<b>Jabiru Service Letter: Starter Solenoid</b>			<b>JABIRU AIRCRAFT PTY LTD</b> P.O. Box 5792 Bundaberg West Queensland, Australia. Phone:+61 7 4155 1778 Fax:+61 7 4155 2669 Email: info@jabiru.net.au		
<b>JSL 009-1</b>	Release Date: 5th June 2013	Effective Date: 5th June 2013	Affected Models: See Sheet 1	S/No. Range: See Sheet 1	Page 1 of 3

**SERVICE LETTER: JSL 009-1**

**Subject: Starter Solenoid**

**Figure 1 – Part to be Replaced / Discarded / Destroyed**

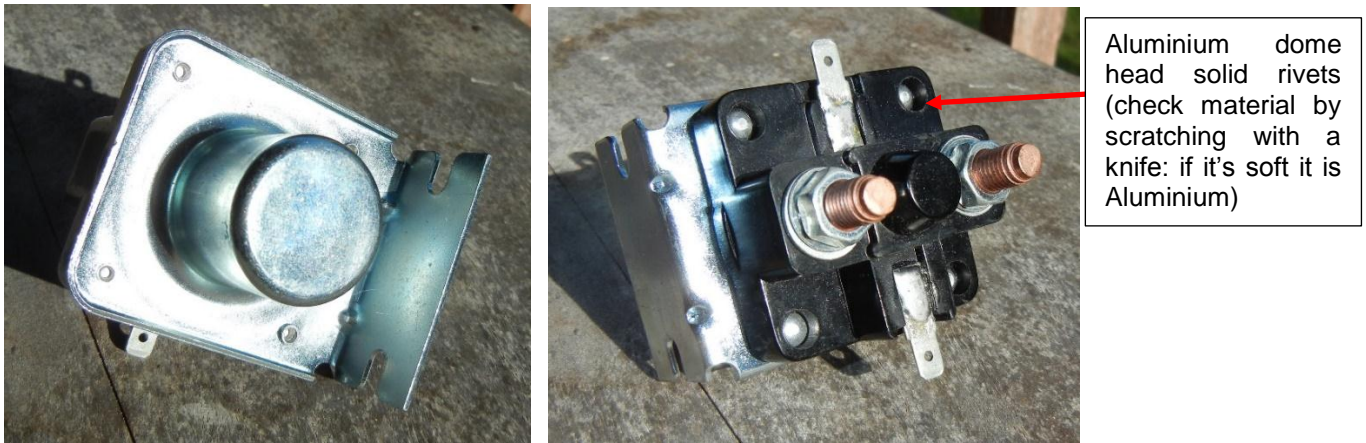
- The Jabiru Quality System has identified a potential issue with the starter solenoids identified above.
- Weakness in the rivets used in the part can potentially result in a failure condition where the solenoid will stick in the “ON” position regardless of the application of the starter circuit.

- The parts in question were shipped between October 2012 and May 2013
- Parts are identified on invoices as P/No. TPI1249N when ordered as a spare parts item.
- An example of the part to be discarded/replaced is shown in Figure 1. Serviceable parts are shown in Figure 2 and Figure 3.

- Where the part has not been fitted: Destroy and discard it to ensure it is not accidentally used at a later date. Contact Jabiru Aircraft Spare Parts if a replacement part is required.
- Where the part has been fitted: Inspect the part to ensure all rivets are intact. Repeat inspections at normal maintenance until the part is replaced. Contact Jabiru Aircraft Spare Parts for a replacement part and, once received, fit during the next scheduled maintenance.
